# Program Bulletin

## CUSTOMER SATISFACTION PROGRAM

**SUBJECT:** Engine Harness Chafing On EGR Stud

**MODELS:** 2015 Chevrolet Silverado HD  
2015 GMC Sierra HD  
Equipped with the Duramax Diesel 6.6L Engine (RPO LML)

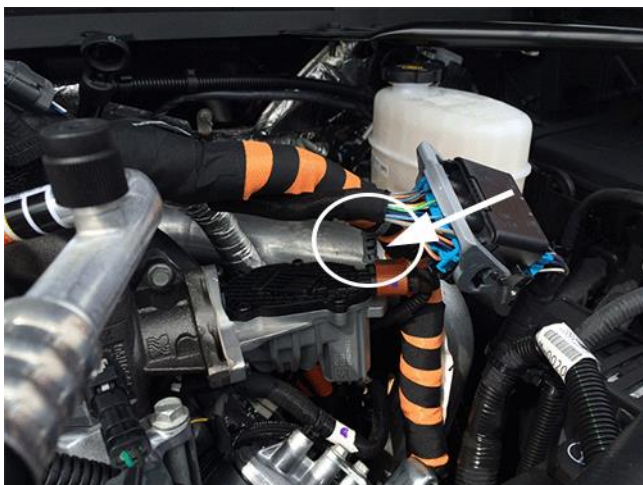
1. Open hood and install fender covers.
2. Inspect the main engine harness for any damage. If any damage is found, repair wire(s). Refer to *Wiring Repairs* in SI before proceeding to step 2.

3. Disconnect the X107 (36 way) connector and reroute the male end under the main engine harness (orange flex wrap) and reconnect X107 connector.

4. Locate and install the gray standoff clip onto the EGR stud.
5. Remove fender covers and close hood.
